**GMP #70**

**SUBJECT:** Preliminary Approval of Sewage Discharge Systems  
Sewage - Discharge - Approval

Re: Request for preliminary approvals of "AQUAROBIC: THE VIRGINIA 600 MINI-PLANT/FILTER" under the Alternative Discharging Sewage Treatment Regulations for Single Family Dwellings (DSTR).

**THE VIRGINIA 600 MINI-PLANT / FILTER  
AND DISINFECTION IN FIBERGLASS TANK**

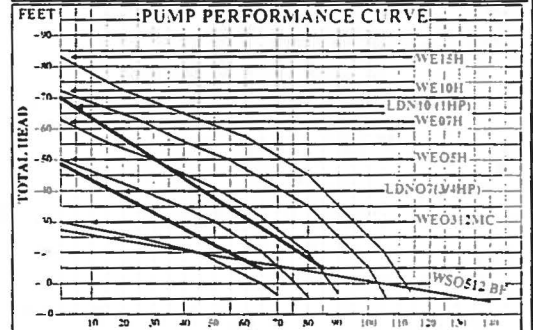
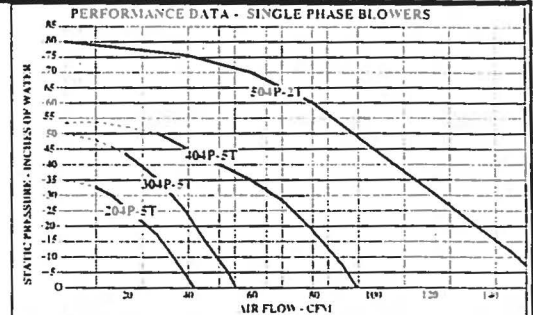
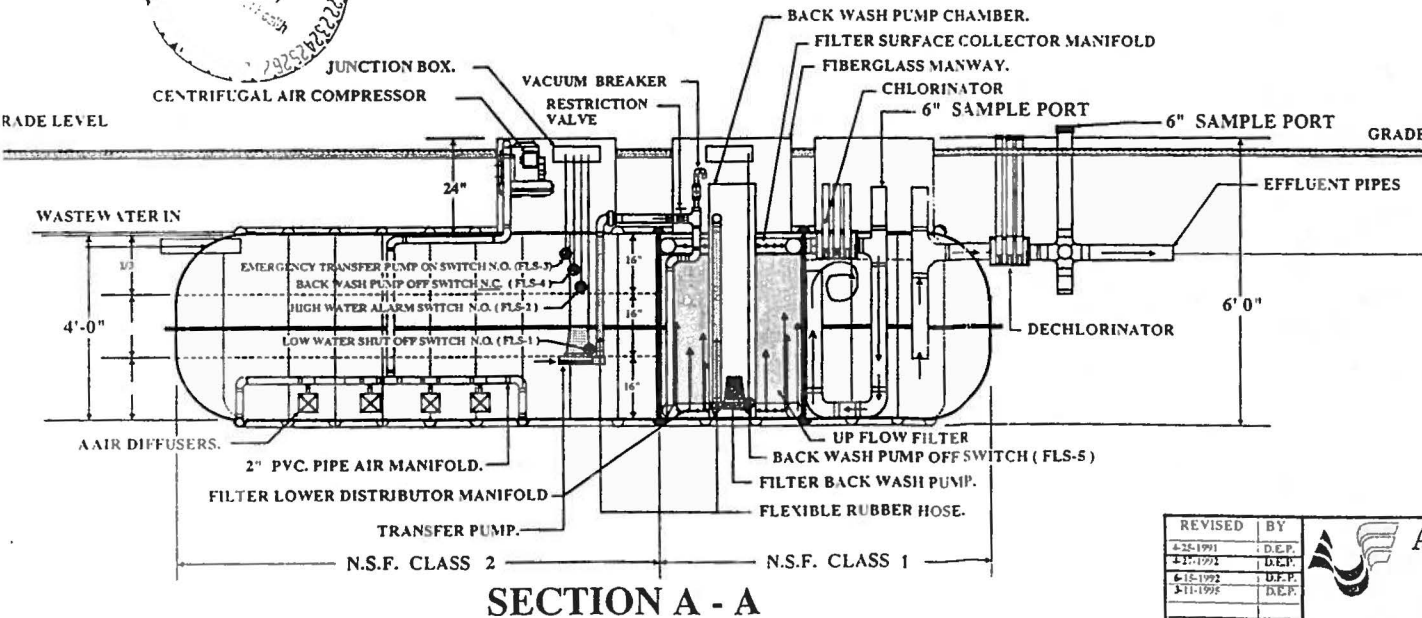
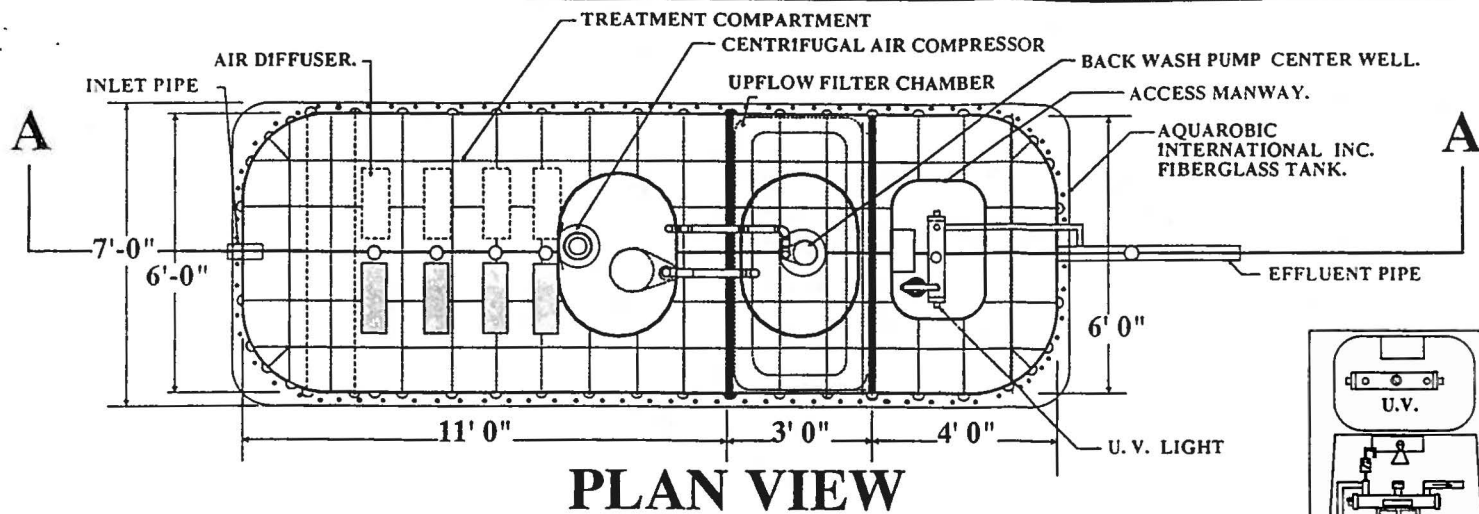
- 1) Preliminary approval is granted to the Virginia 600 Mini-Plant/Filter (mini-plant), as shown in attachment 1, for discharges to dry ditch or intermittent streams of 500' or more (IS/DD 500) for design flows up to 600 gpd. This sewage treatment system consists of a 6' wide by 11' long by 4' deep aerobic batch activated sludge compartment which receives the waste directly from the house connection. Clarified wastewater from the aeration chamber is then pumped to a 3' wide by 6' long by 3.6' deep up flow gravel filter. The gravel in the filter will have an effective size of less than 3.5 mm and a uniformity coefficient of less than 4.0. Virginia Department of Transportation's 78, 8 or 9 gravel should meet the effective size and uniformity coefficient. A pump is provided to return the liquid and any solids that accumulated in the filter back to the aeration chamber. Wastewater from the up flow filter passes through a tablet chlorinator and then enters the chlorine contact tank. The chlorine contact tank has an approximate volume of 600 gallons. Chlorinated wastewater then passes through a tablet dechlorinator. If ultraviolet light disinfection is used then the flow from the upflow filter must be limited to the capacity for the ultraviolet unit.

THE MINI-PLANT # F54291-7.5 - 750 GAL/DAY  
FILTER UNIT DISCHARGING TO A  
CONSTRUCTED WETLAND WITH DISINFECTION  
IN FIBERGLASS TANKS FOR PARCEL 12A,  
FOREST HILLS ESTATES, PRINCE WILLIAM  
COUNTY, VIRGINIA.

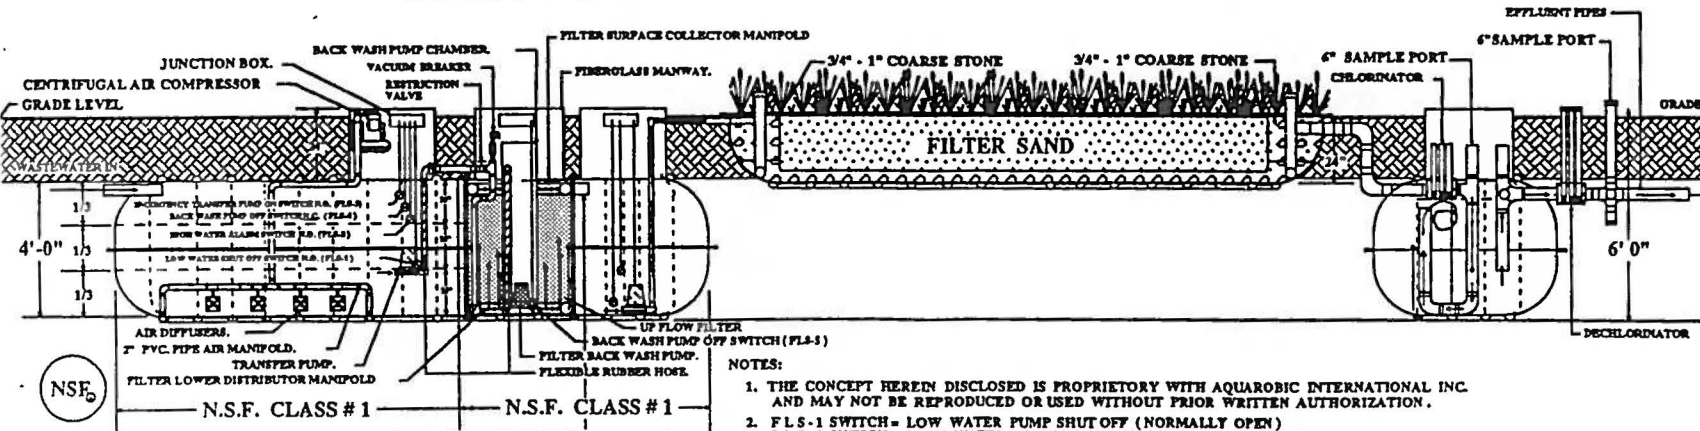
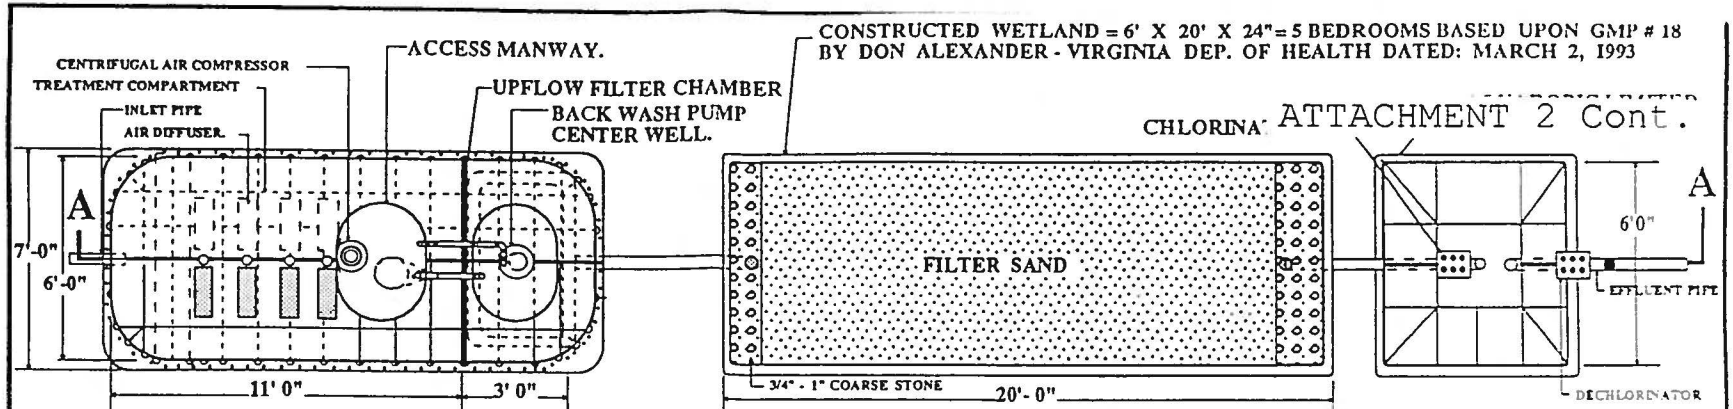
- 3) Preliminary approval is granted to the Virginia 600 mini-plant/filter, as described in 1) above, with a constructed wetlands for discharges to IS/DD 250. This system is shown in attachment 2. The wetlands must be a minimum of 100 ft<sup>2</sup>. The components of the wetlands may be adjusted as new developments in wetlands treatment technologies progresses.
